10682 Banbury Oil Deport

Technical Note 5: Response to EA Drainage Comments 16th January 2023

8th March 2023

EA Flood Model Undefended scenario 1 in 100yr +15%CC

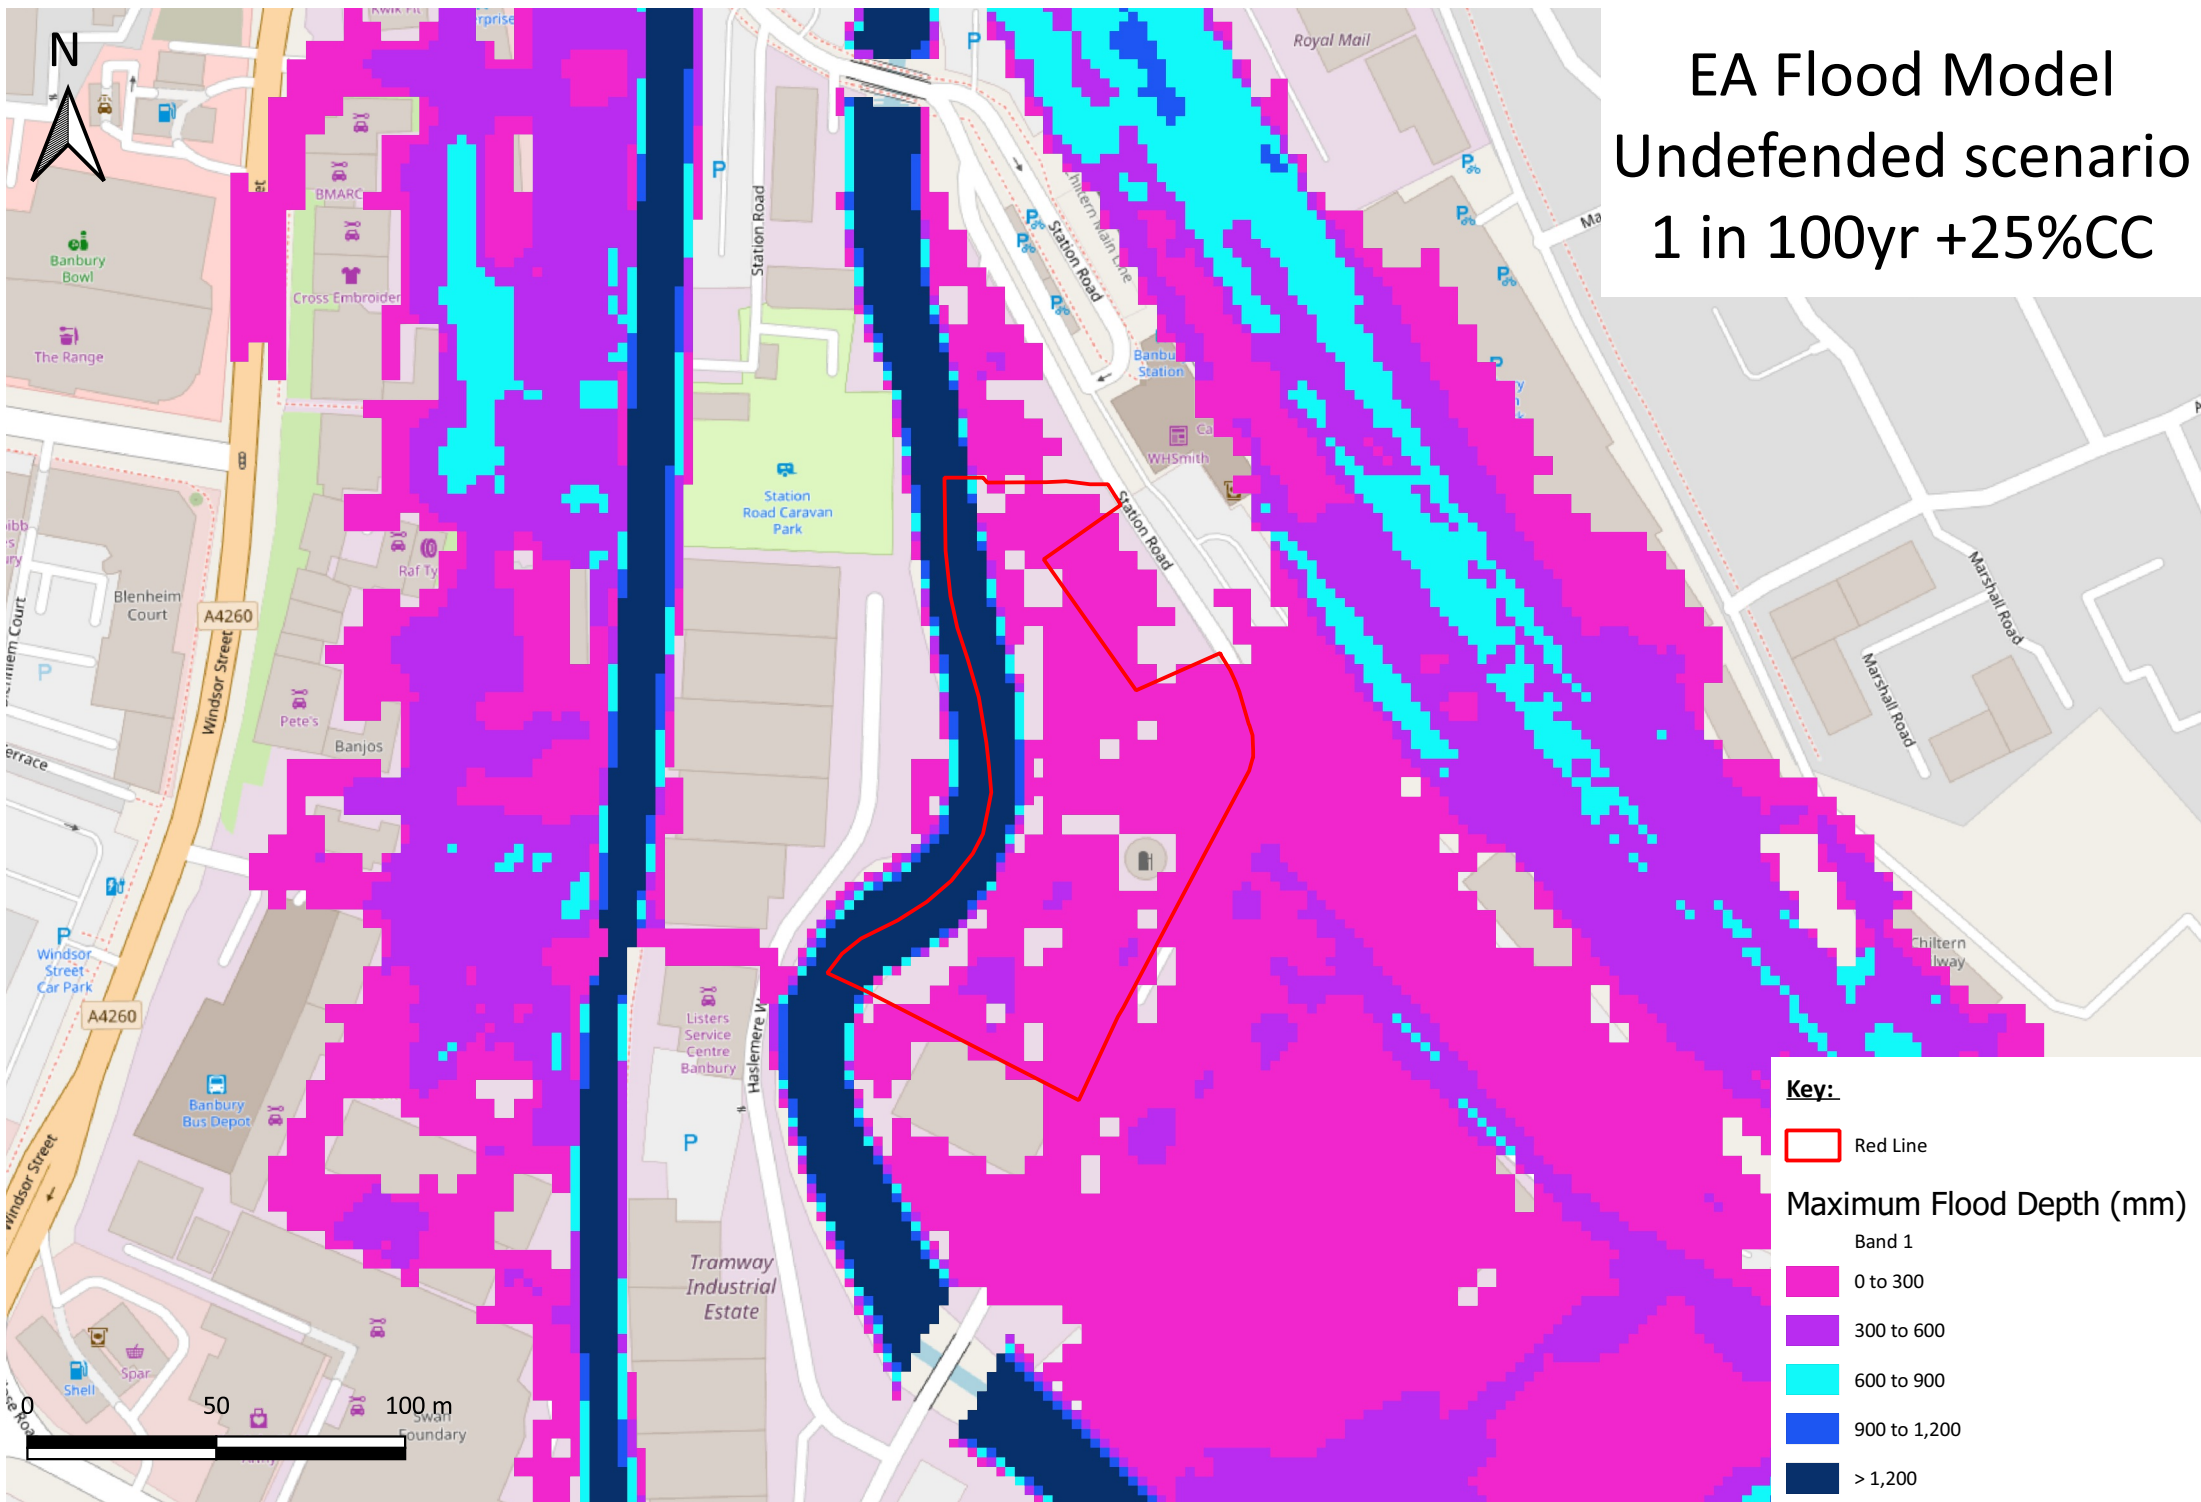
- 2.1 *The applicant has not provided details of any of the other climate change scenarios for this catchment and to proceed with detailed designs based on this extreme representation of flooding is unlikely to result in a viable development. The applicant needs to also consider the higher central climate change scenario (25%). Should this result in increased flood risk to the nearby rail station and tracks, compensation to address this will need to be designed and shown to be feasible in order for planning permission to be granted. Should the rail station and be unaffected by the development proposal using the 25% scenario, then it may only be necessary to consider the central climate change allowance of 15%.*

- 2.2 The EA's model has now been run to illustrate the 25% climate change scenario and 15% climate change scenario, with the modelled results provided in **Appendix A**. Due to the extent of flooding across Banbury, in both scenarios the development Site is still affected by flooding coming in from the railway line.

- 2.3 The maximum flood depths across the Site are:
 - 1 in 100 year plus 49% climate change storm event - 0.4996m
 - 1 in 100 year plus 25% climate change storm event - 0.406m

- 1 in 100 year plus 15% climate change storm event - 0.346m
- 2.4 The application Site forms part of an allocated site under Planning Policy BAN1 Banbury Canalside. The Site is also protected by the Banbury Flood Alleviation Scheme, the model has also been run in the defended scenario. Modelled results provided in **Appendix B**. As shown in these results the proposed development blocks are unaffected by flooding in the 1 in 100 year, 1 in 100 year plus 15% climate change, 1 in 100 year plus 25% climate change and 1 in 100 year plus 49% climate change storm events.
